Model: Model K-C3 GDI model		Date: 19-Sep-07	No.: MB245020
Modified Article: New part number was added		Prepared by: Y.Yoshida	
From: 1st Tech. Support Sec. Service Support Dept.			
Reason for Modification:	<input checked="" type="checkbox"/> Parts catalog correction <input type="checkbox"/> Vendor change <input type="checkbox"/> Other <input type="checkbox"/> To facilitate assembly <input type="checkbox"/> To improve reliability <input type="checkbox"/> To meet standards <input type="checkbox"/> Part standardization <input type="checkbox"/> Product Safety    (    )

**Change:** This part was added.

NEW Part	Description	Q'ty	Int	Page	Index	Note
B8955171	PCB: DONGLE: ASS'Y	0→1	1	3	9

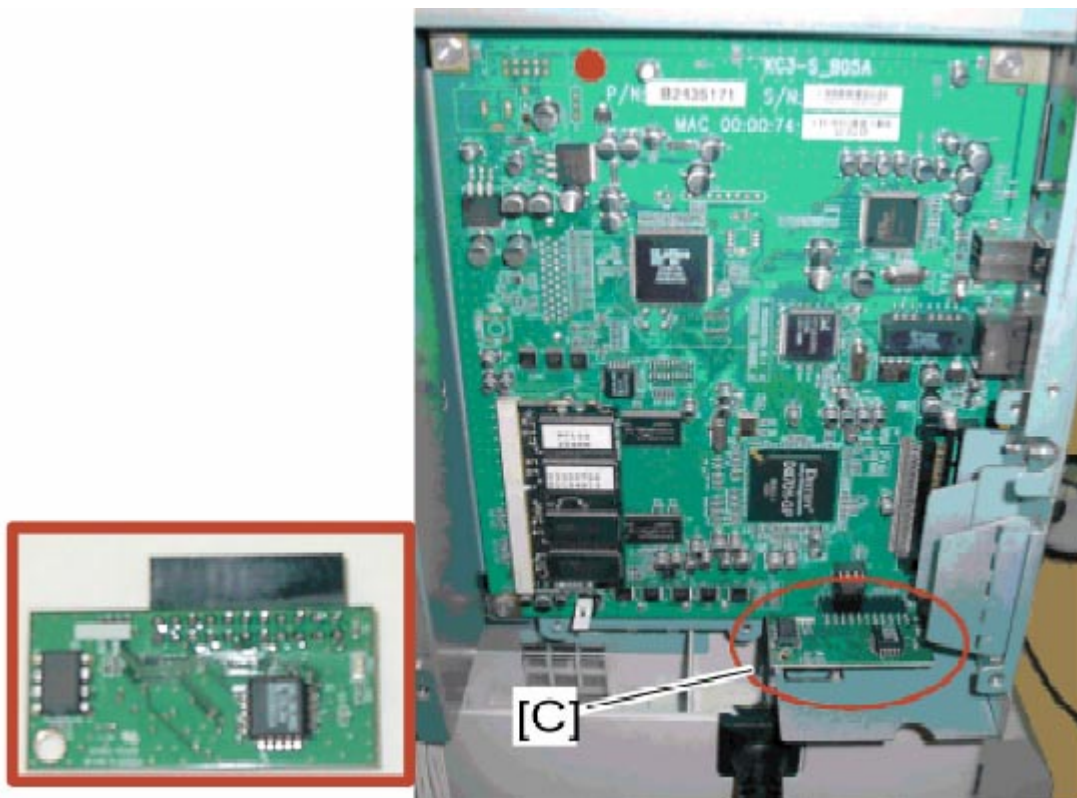
**Reason:** Requests were received from the field.
